Agenda
Village of Arlington Heights
Design Commission
Community Room, 3rd Floor

Arlington Heights Village Hall
33 S. Arlington Heights Road
Arlington Heights, IL 60005
October 25, 2016
6:30 PM

- A. DC#16-106 - 1116 N. Douglas Ave. - SF/Teardown
- B. DC#16-107 - 1225 N. Walnut Ave. - SF/Teardown
- C. DC#16-124 - Esplanade at Arlington Heights - 2920-3020 W. Euclid Ave. - Sign Variation

FRONT ELEVATION
SCALE: 1/4" = 1'-0"

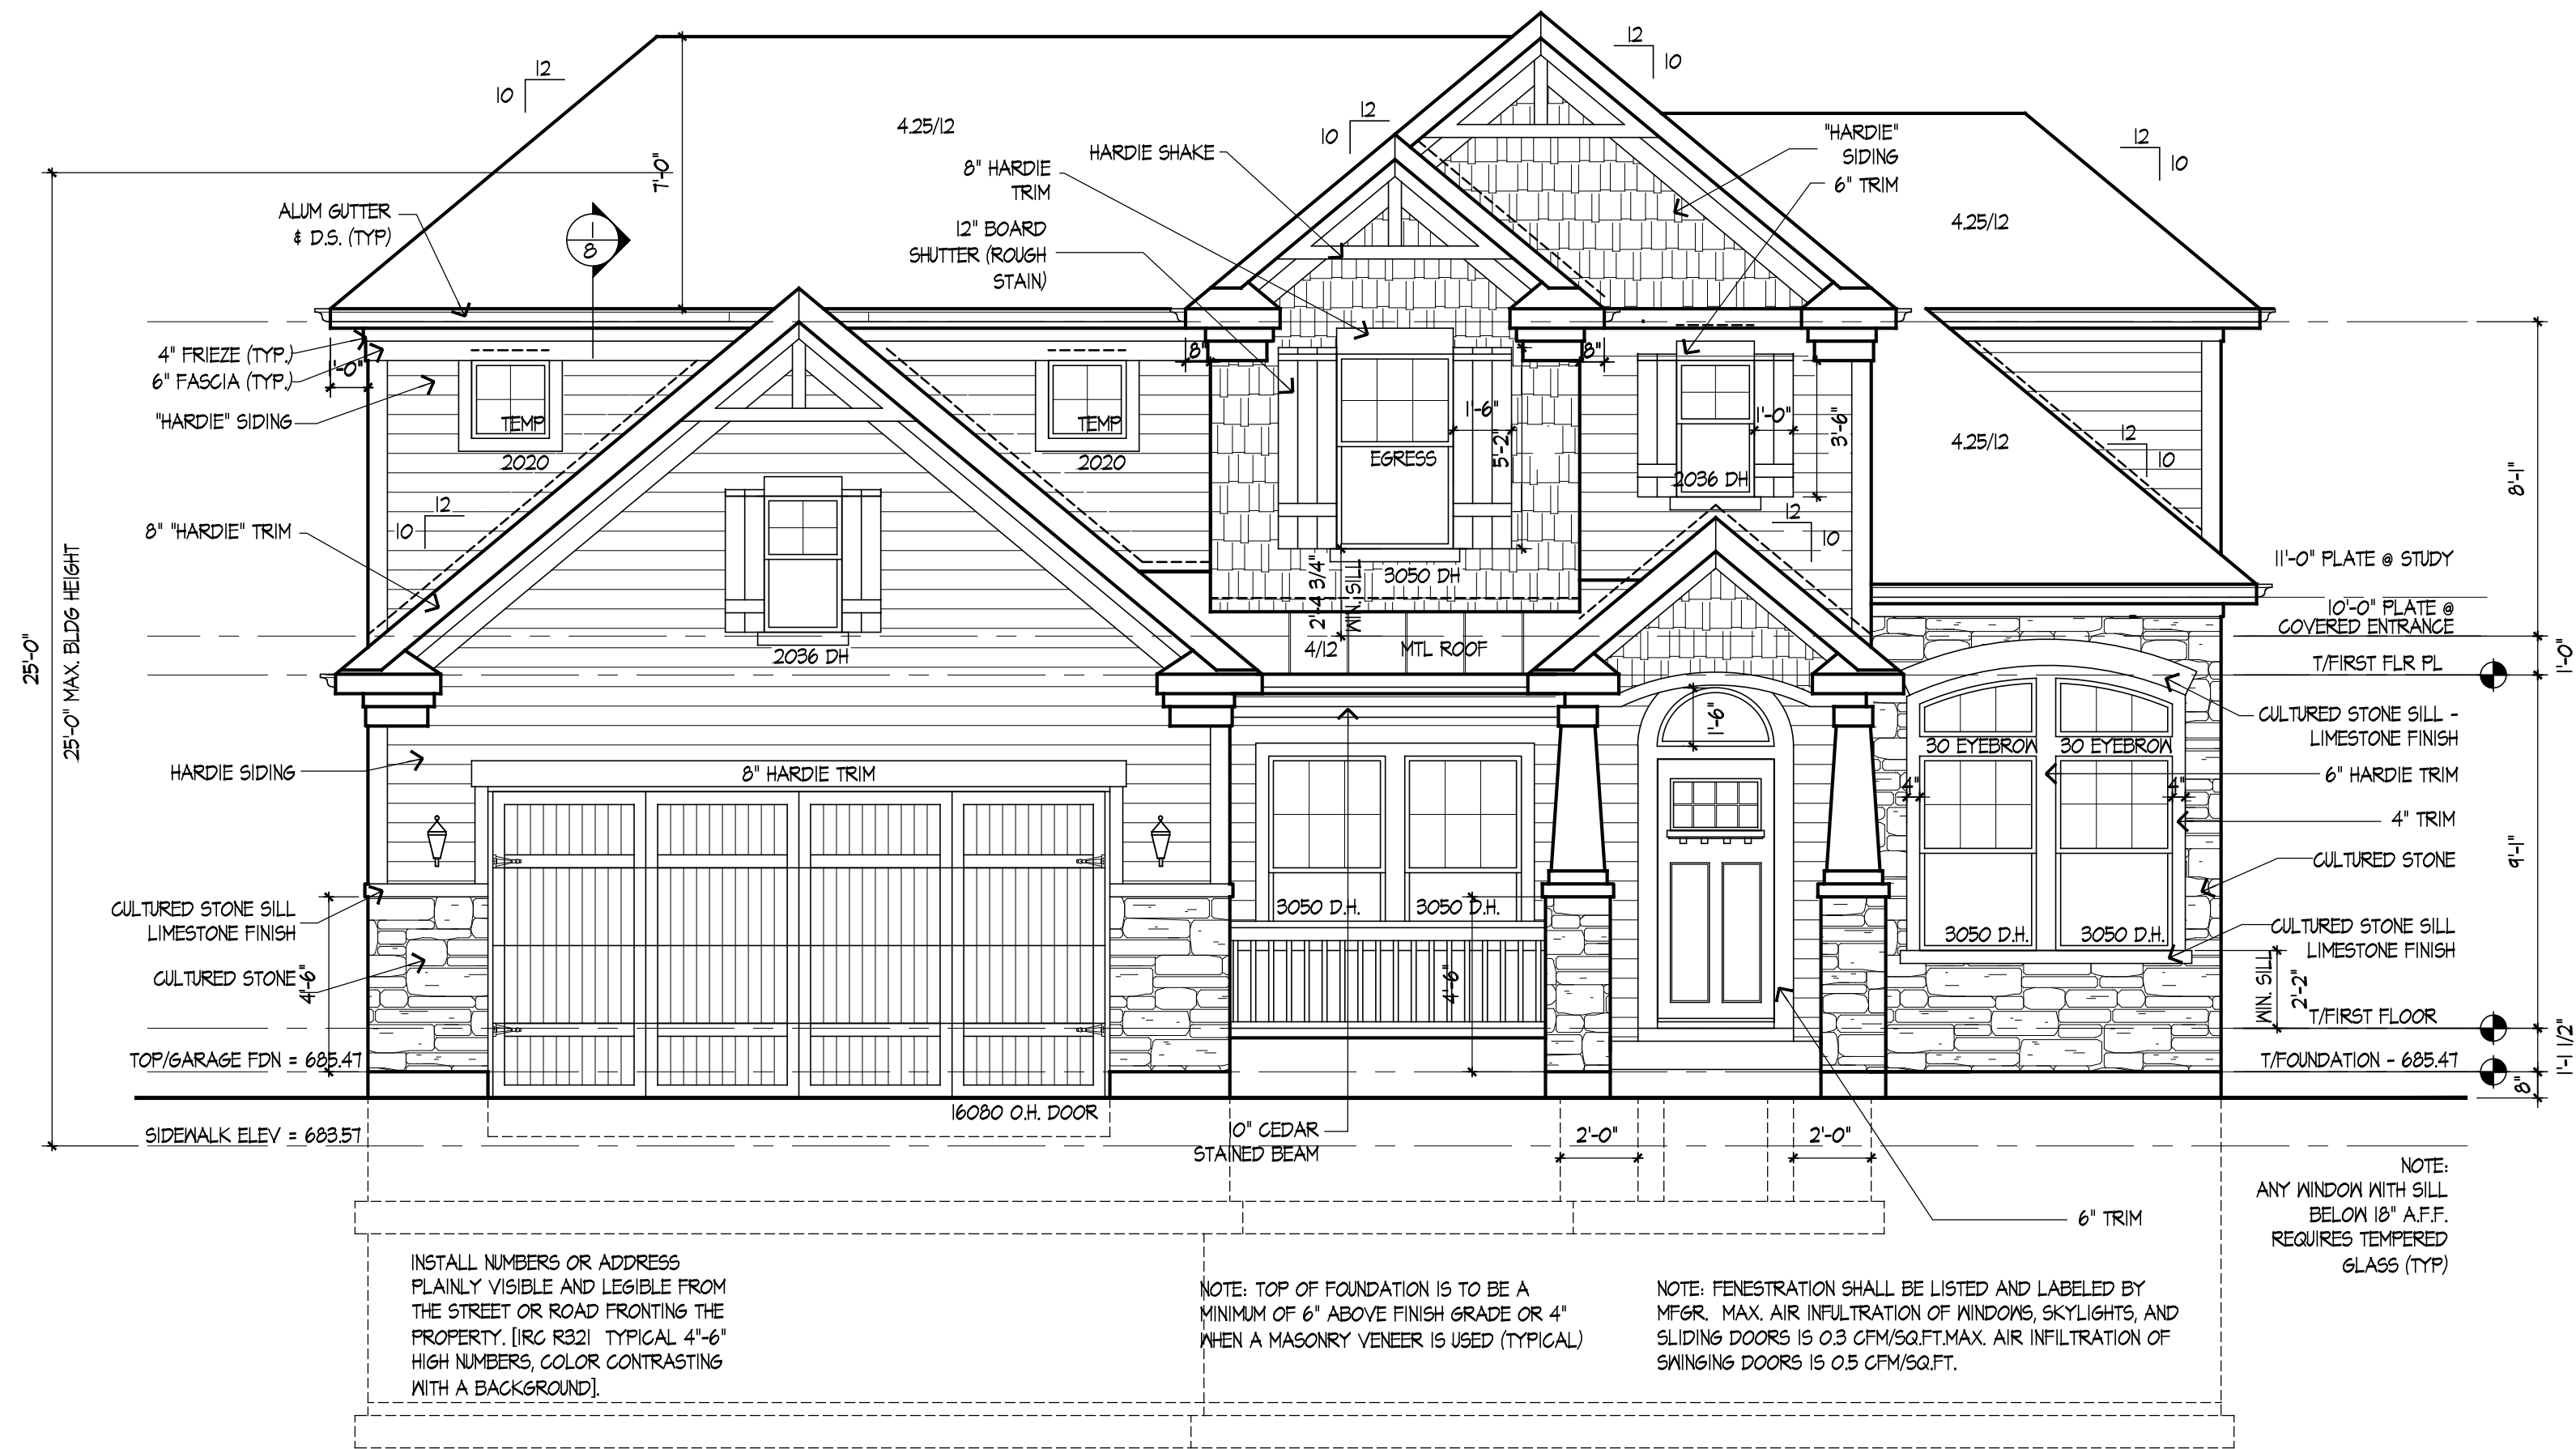
1. Reduce the prominence of the garage wall by extending the front porch to align with the face of the garage.
2. Continue the detailing from the front elevation onto the side of the garage by returning the stone base to the end of the one story garage wall.
3. Add a window in the left side wall of the garage.

It is recommended that the Design Commission approve the proposed new single-family residence to be located at 1116 N. Douglas Avenue. This recommendation is subject to compliance with the architectural plans received on 9/9/16, and the following:

FRONT ELEVATION
SCALE: 1/4" = 1'-0"

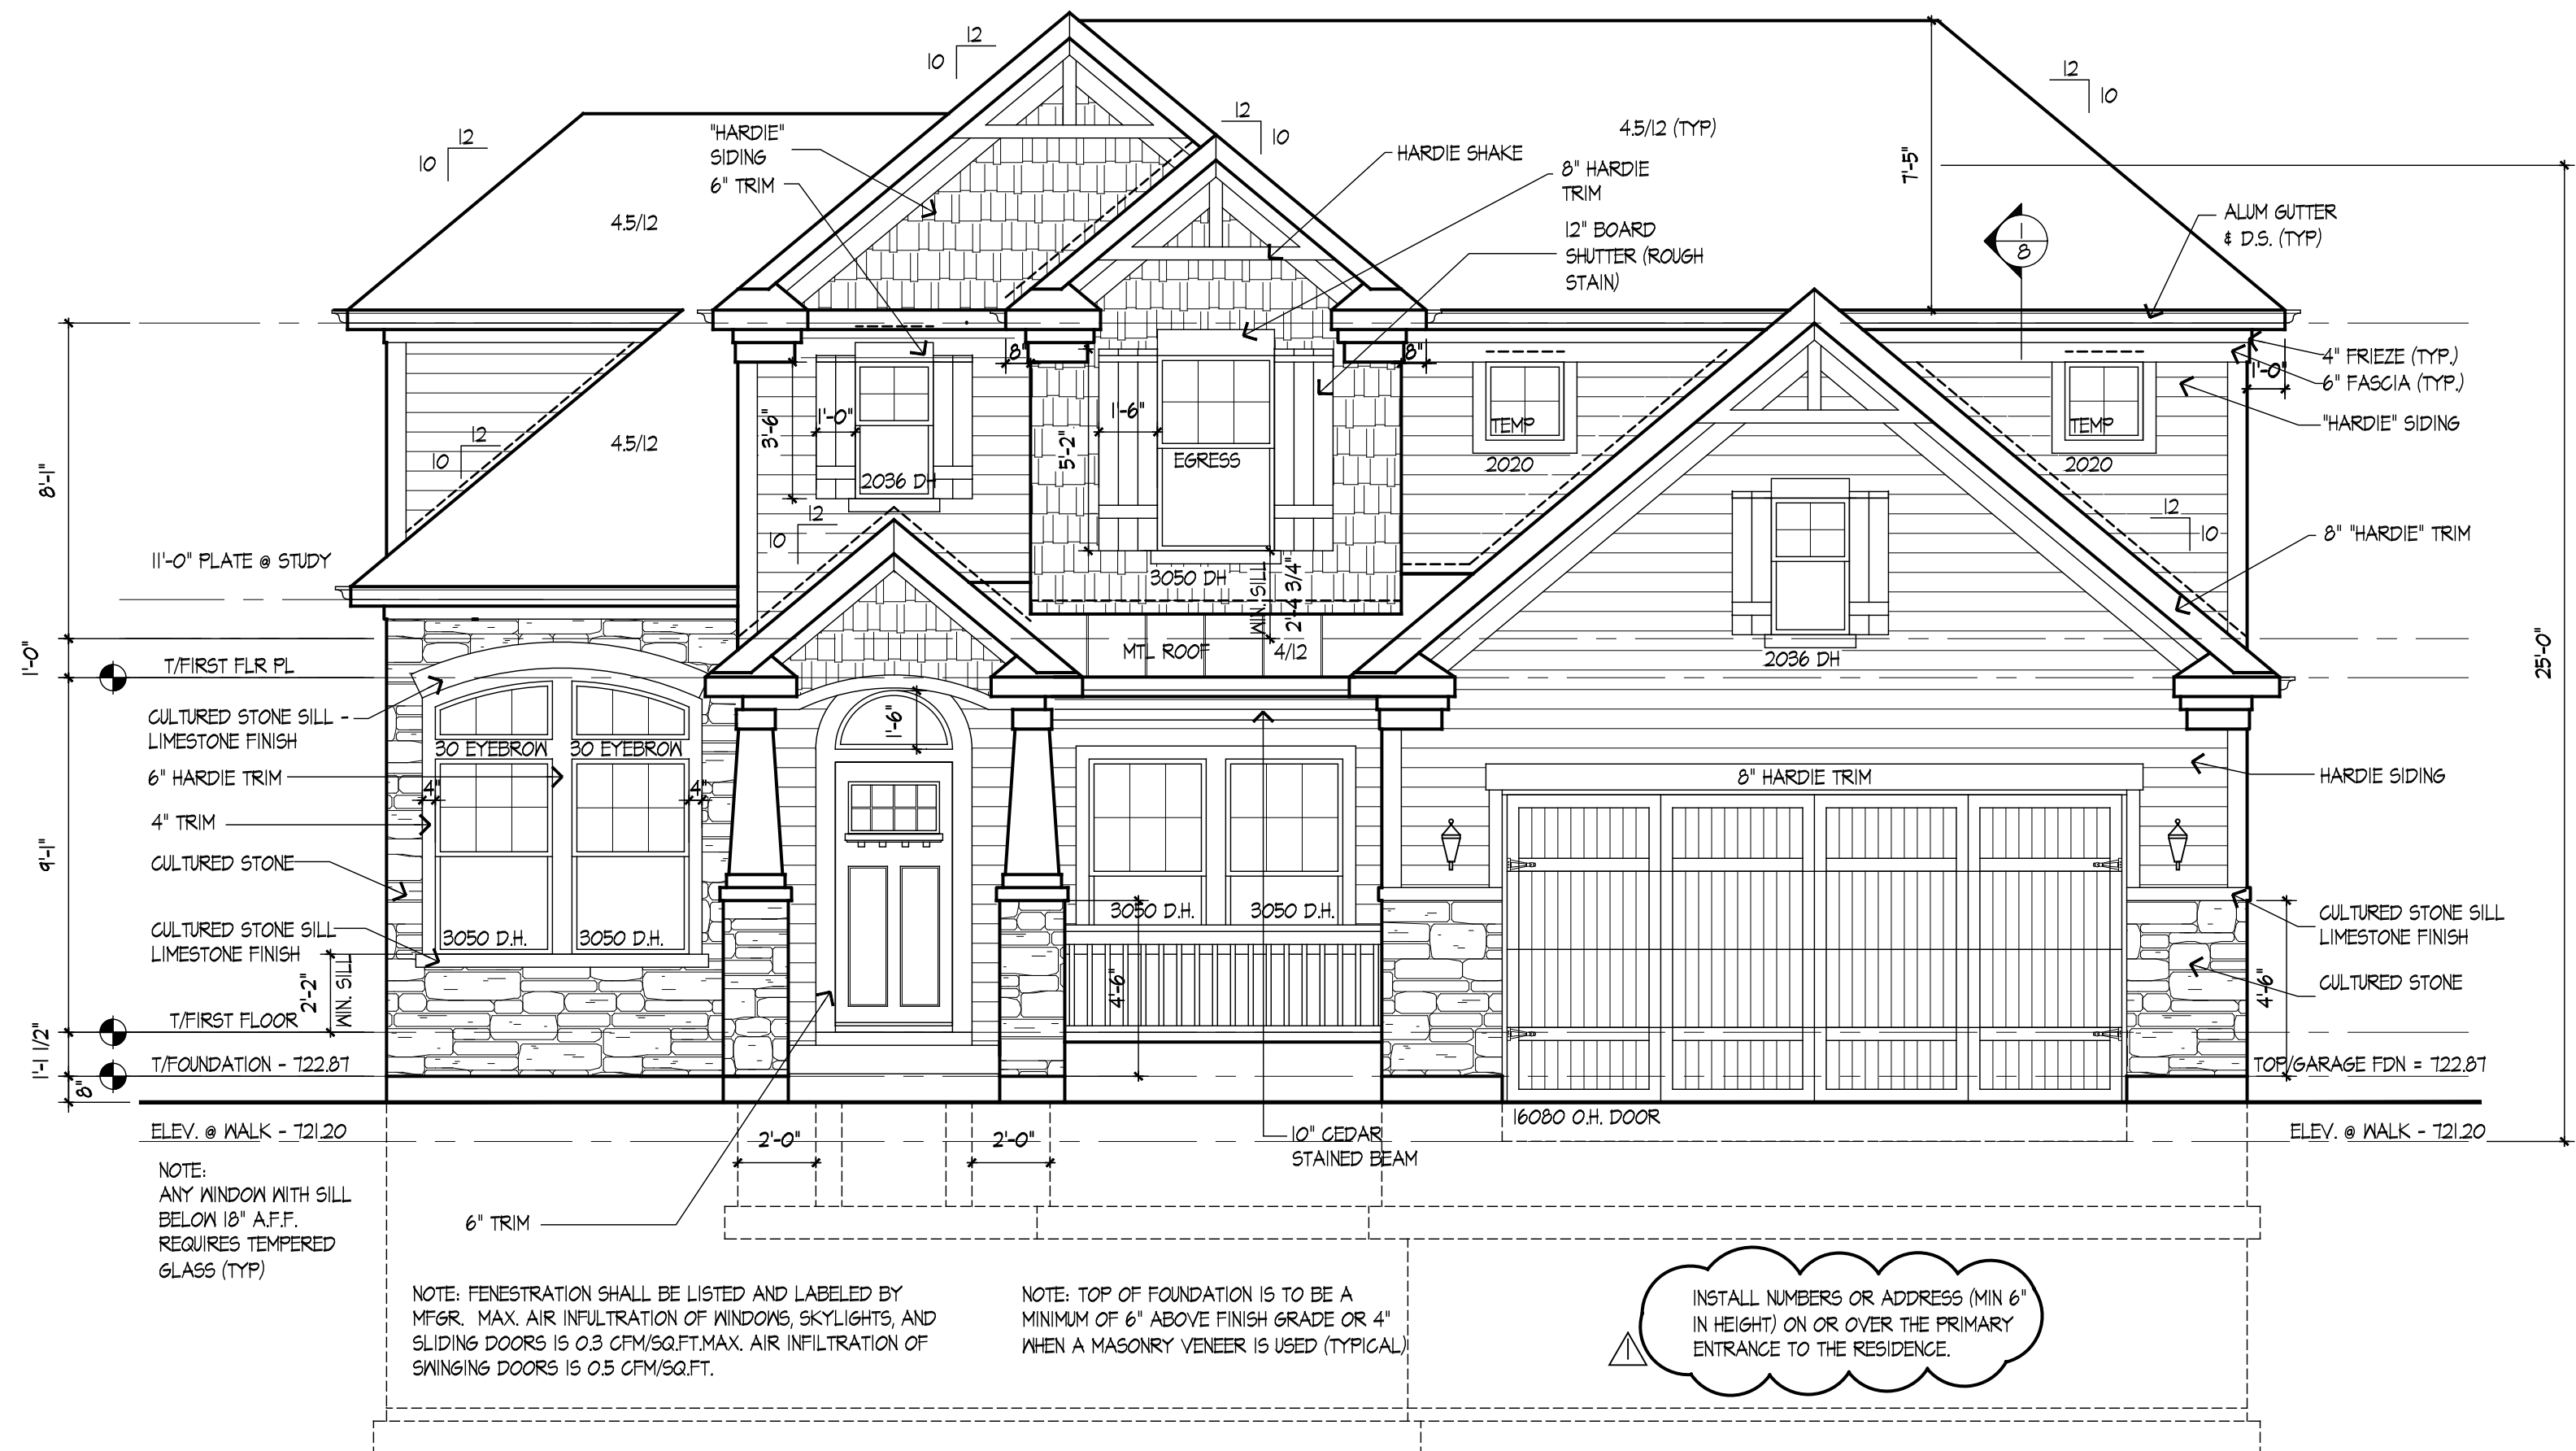
1. Reduce the prominence of the garage wall by extending the front porch to align with the face of the garage.
2. Continue the detailing from the front elevation onto the side of the garage by returning the stone base to the end of the one story garage wall.
3. Add a window in the left side wall of the garage.
4. Reduce the visual height of the rear elevation by adding a continuous row of shrubs or a stone base below the first floor line to simulate a stone foundation wall. The shrubs or stone base should wrap around the side elevations.

It is recommended that the Design Commission approve the proposed new single-family residence to be located at 1225 N. Walnut Avenue. This recommendation is subject to compliance with the architectural plans received on 9/9/16, and the following:
